Agenda Item 3
1425 Telegraph Road
New Single-Family Residence on a Vacant Lot

Preliminary consideration of plans for a new two-story single-family residence on a vacant lot.

Preliminary Staff Review Comments

EAST AND WEST ELEVATIONS

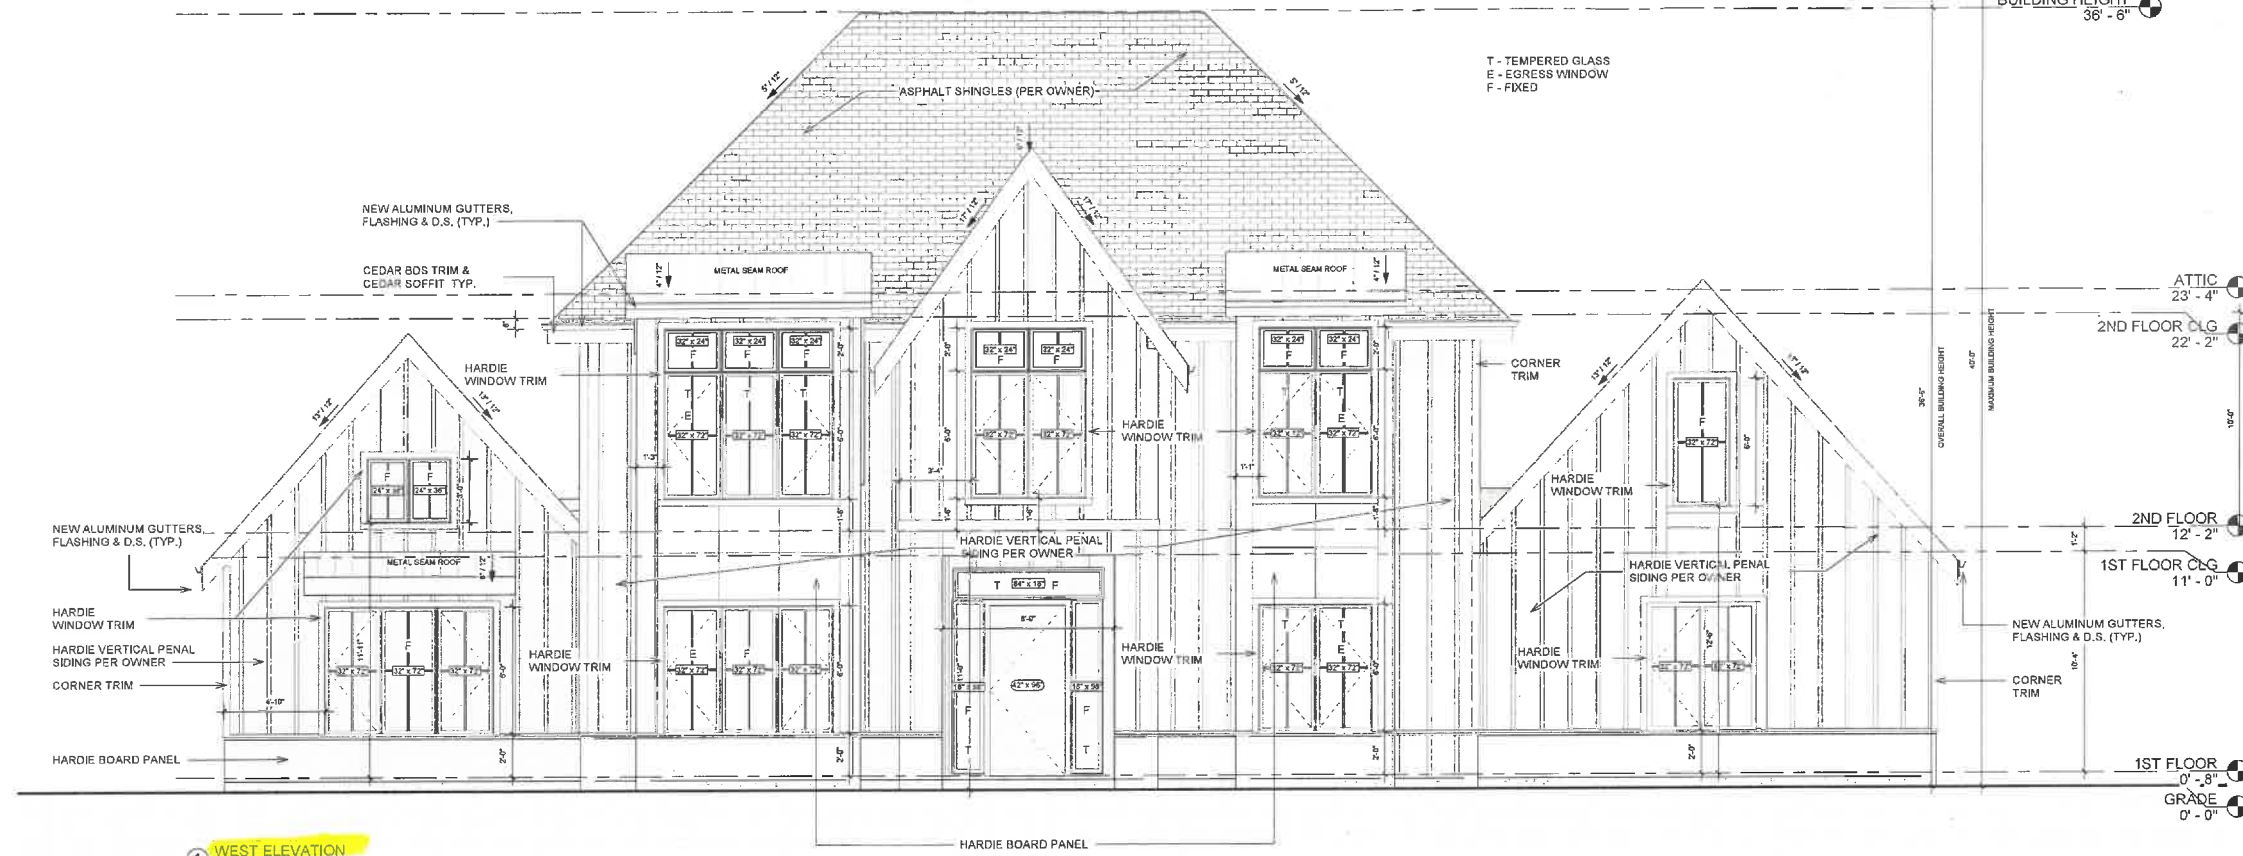
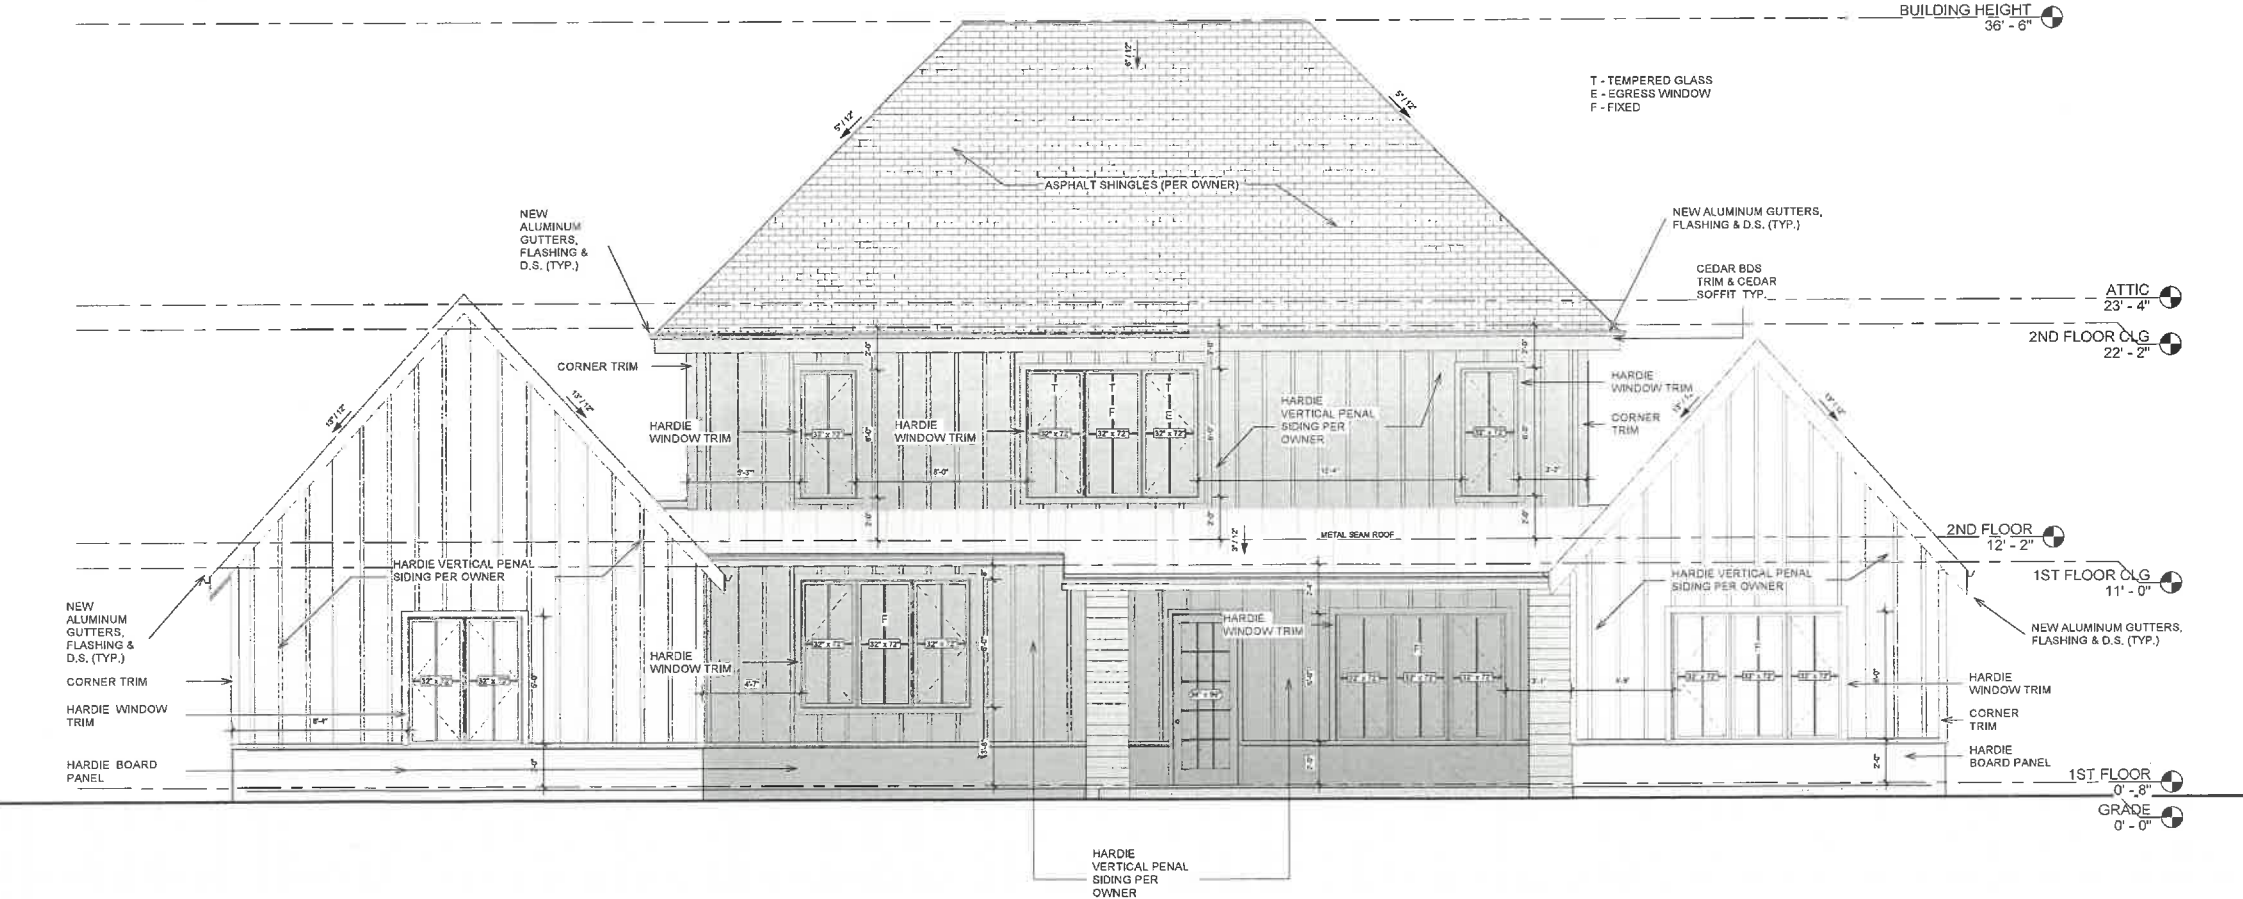
The statement of intent describes the selected style of architecture as “modern country estate”, a trending architectural style also recognized as modern farmhouse. On the west elevation, a steeply pitched central gable indicates the main entrance. Adjacent to the entrance are two asymmetrical two-story square bay windows with shed roofs. The central massing has a prominent hipped roof and the adjacent asymmetrical wings of the house are defined by gables. On the left wing, a set of short clerestory windows are separated from three first floor windows by an eyebrow roof. On the right wing, a single clerestory window is separated from two first floor windows by a black panel.

The prominent hipped roof on the central mass and asymmetrical gabled wings are mirrored on the east elevation. A metal standing seam roof divides the first and second floor and covers the rear porch. A thick column supports the porch to the left of the rear door. Two windows are placed on the larger, left gabled wing of the home while three are placed on the smaller, right gabled wing of the home.

Staff Recommendation: Study and refine the hierarchy of massing to better balance the central mass with the wings on the east and west elevations. Consider a more symmetrical, proportional design.

Staff Recommendation: Study and refine the roof forms to differentiate the primary and secondary masses.

Staff Recommendation: Study and refine the east and west elevations to develop a design with a more regular and proportional arrangement of openings and design features to better adhere to the City's Residential Design Guidelines.

NORTH AND SOUTH ELEVATIONS

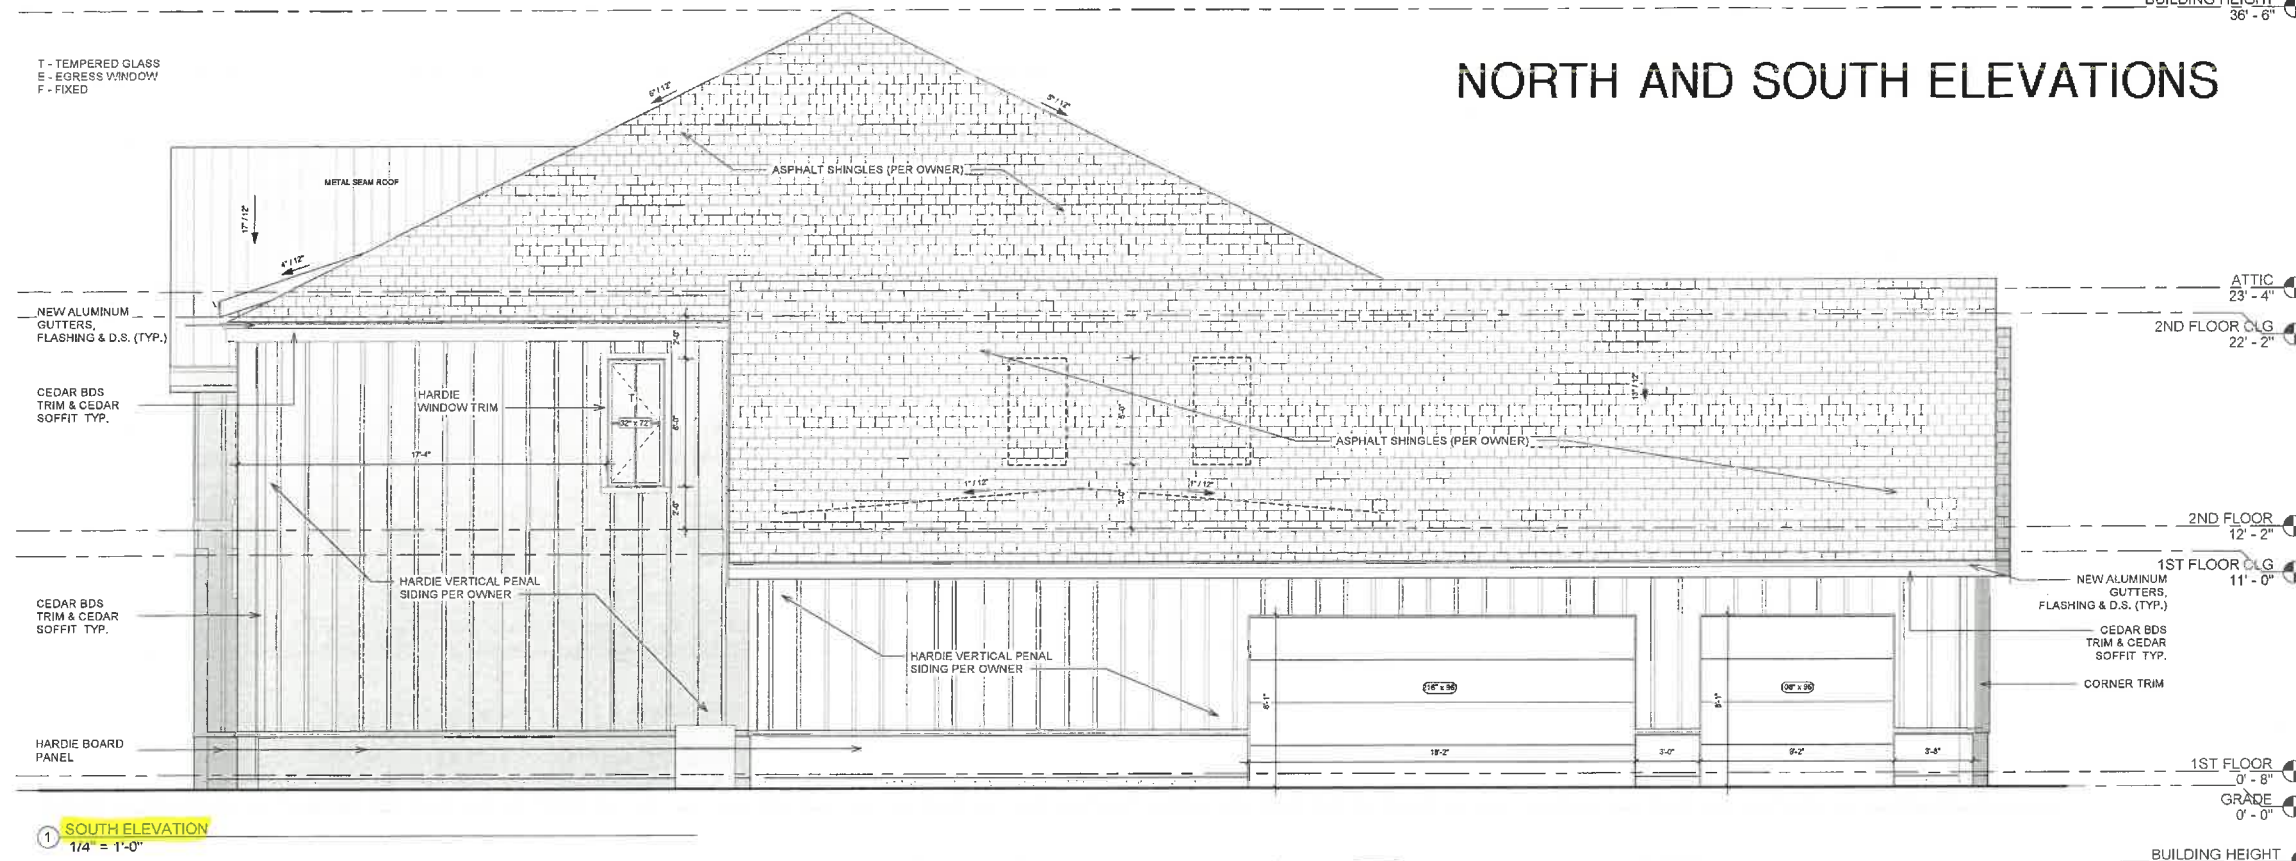
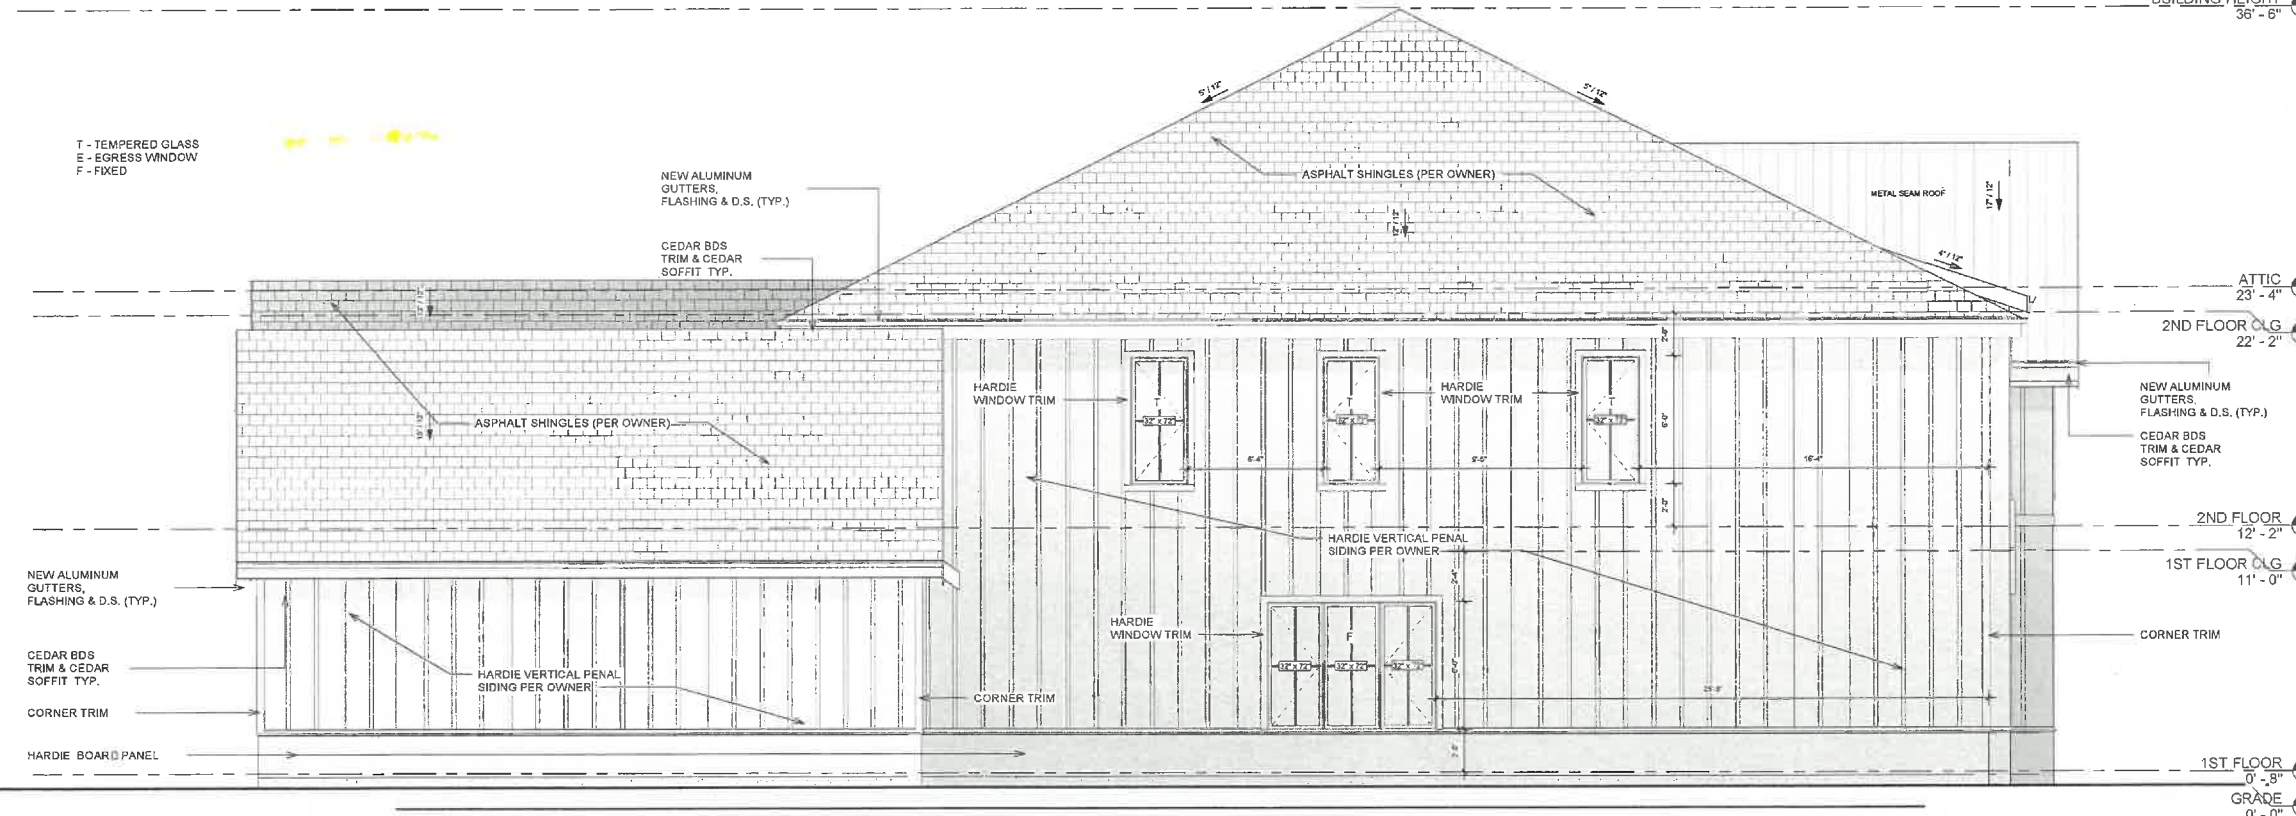
There is only one window on the south elevation and only a limited number of windows on the north elevation. Solid walls and roof massing dominate the elevations.

Staff Recommendation: Study and refine the north and south elevations to achieve a balance between window and door openings and expanses of solid wall. Consider the use of design elements like dormers to break up the roof massing.

Development Plan TREE SURVEY - PROPOSED FOR REMOVAL

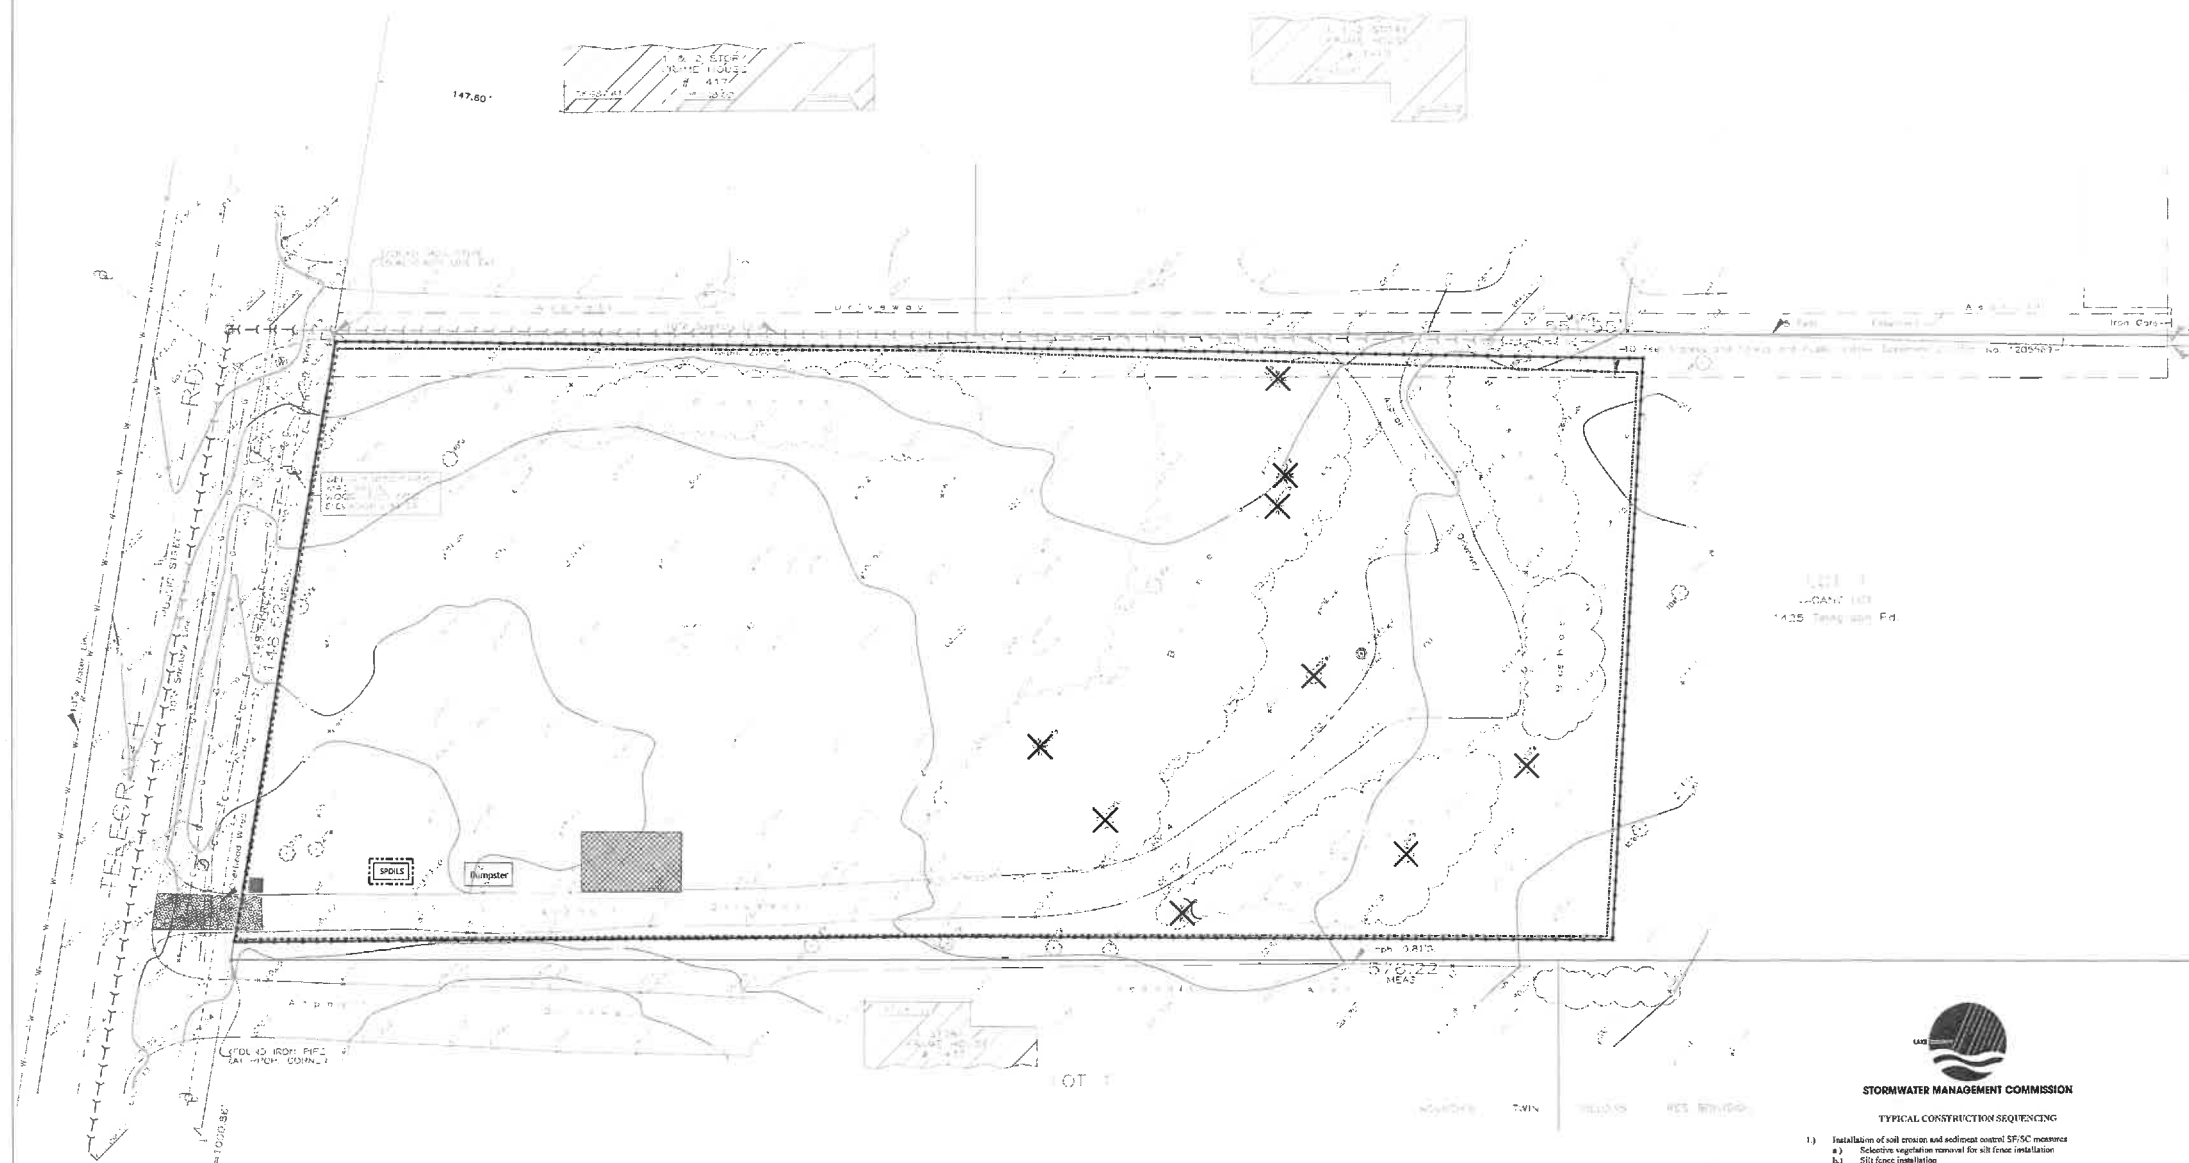
The tree survey and tree removal plan submitted do not align.

Staff Recommendation: Submit an updated tree survey and tree removal plan that fully and accurately document the species, size, and condition of the trees on the site and clearly identifies those proposed for removal.
